| TRANSBAY TRANSIT CENTER PROGRAM                            |
| BEALE STREET AND BUS PLAZA ENTRANCE<br>TRAFFIC SIGNAL WORK |

| DRAWING NO.<br>ET-3.0 |

BEALE STREET AND BUS PLAZA ENTRANCE  
POLE AND EQUIPMENT SCHEDULE

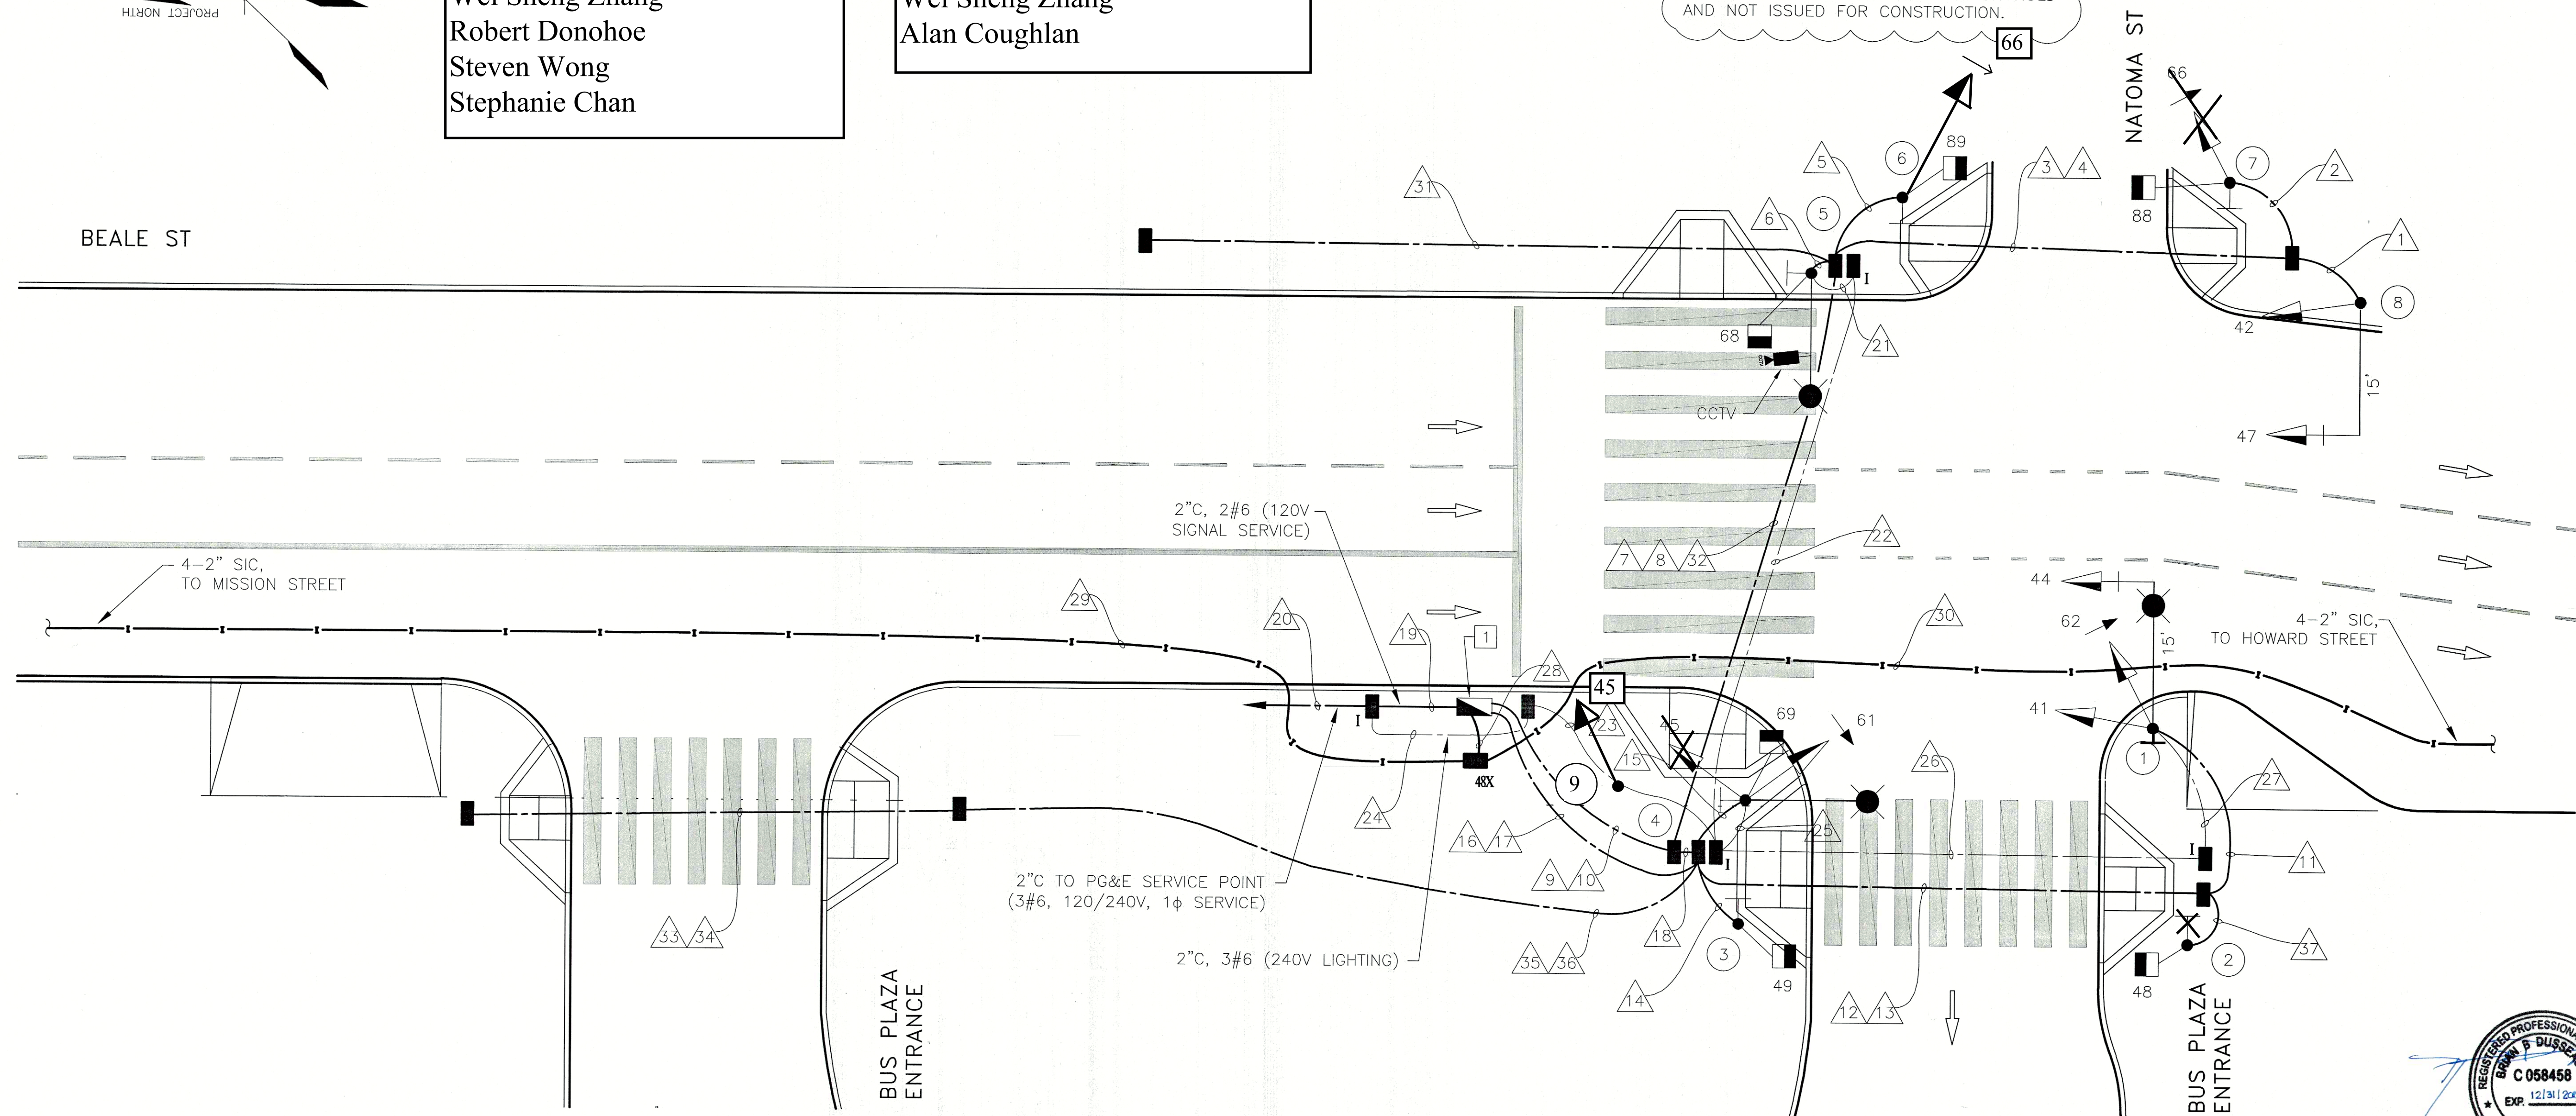
PER SRC 2019-274 REMOVE RIGHT  
ARROWS FOR SIGNALS #41, #44,  
#45. INSTALL CH1 TIMING CARD.  
6/11/2020. S. WONG
